**Outline Planning Application for Mixed Use Development at Barry Waterfront  
(2009/00946/OUT and 2009/00947/OUT)**

**Town and Country Planning (Environmental Impact Assessment)(England & Wales)  
Regulations 1999 (as amended) - Request for a Formal Screening Opinion**

Project title	Waterfront Barry	Job number	122374-00
cc	Richard Keogh Jonathan Kinghorn John Smith	File reference	4-70
Prepared by	Roddy Beynon (Cardiff)	Date	5 October 2010
Subject	Response to Audit of Transport Assessment Rev A

**Merrie Harrier**

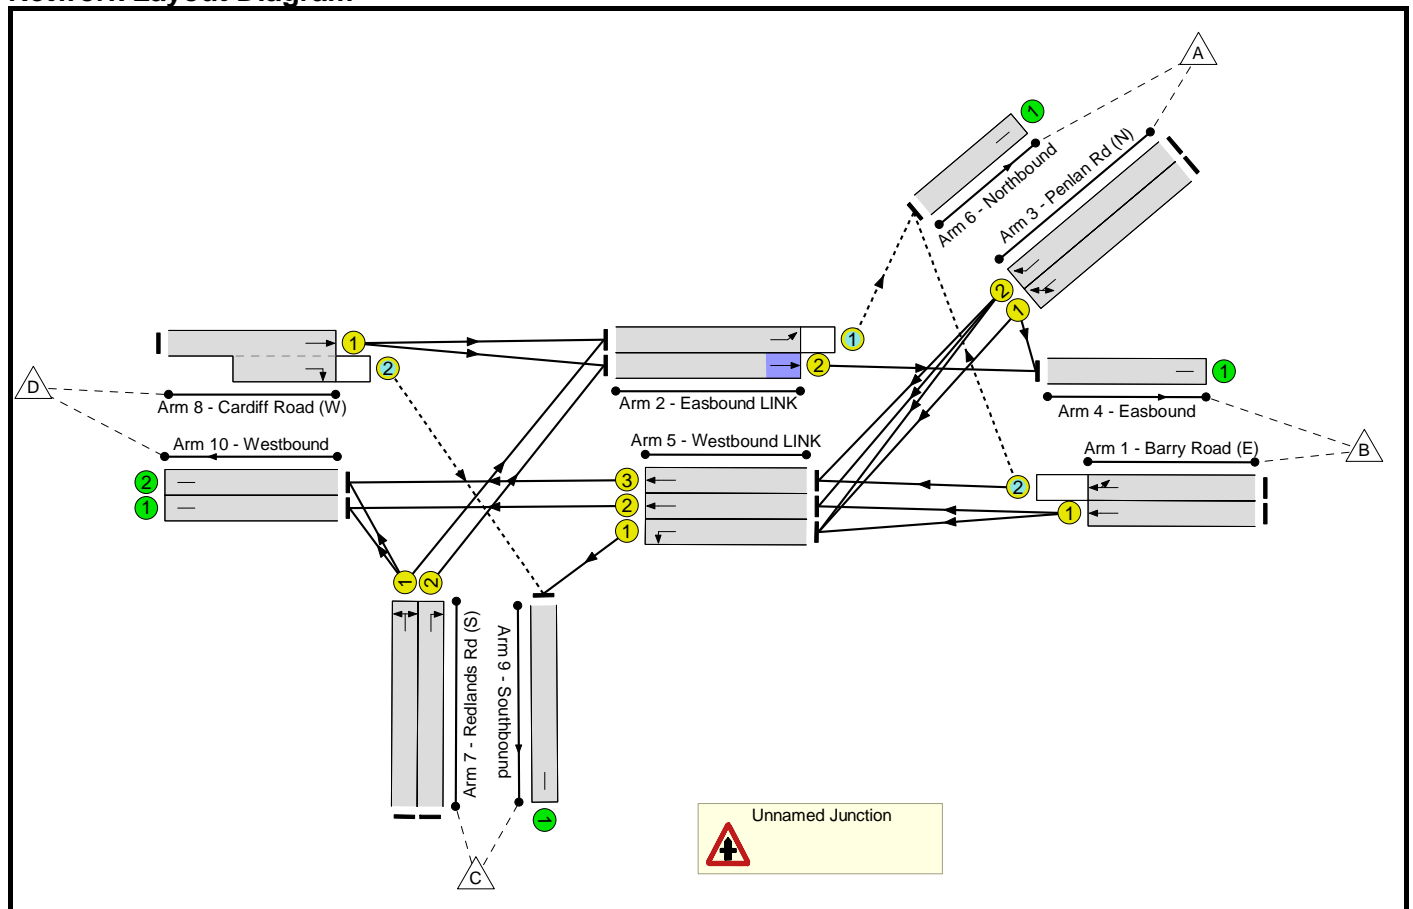
Appendix A of the Revision A audit raised a number of technical points in relation to the modelling of signalised junctions. This section responds to the points raised which are referenced at the start of each section, the bold text relates to the queried areas of the model. Where appropriate minor alterations have been made to the junction models. Results for these revised models are included as appendices A-E.

**Pedestrian crossing on Barry Road east**, site observations show there is little activity at the pedestrian crossing during the peak periods. It is thus considered that its omission would have minimal effect on capacity.

**Phase H left turn into Redlands Road**, the movement is not modelled to experience congestion, the phase has been revised to operate as a left turn filter in an additional stage. This change has a nominal effect.

**Internal Links**, during some scenarios the internal links have a mean max queue (MMQ) above the physical storage but have an end of red queue within storage capacity. As a test queue limiters were applied to the internal links this test forced the mean max queues down and increased the RFC of the feeding arms. In reality when the internal link starts to empty the feeding arm adds to the back of the queue generating a rolling queue that fully depletes before the stage closes down as shown in Figure 1.

Arup has revisited the site following implementation of the Merrie Harrier junction improvements and altered the Linsig model accordingly to more closely replicate the conditions. The two sections of the junction now run on a split stream controller to allow better coordination, phasing/staging has been changed accordingly. The revised model output is included as Appendix A.

Figure 1 shows the back of queue building while the front of the queue is released. The queue becomes fully depleted before the next red stage commences.
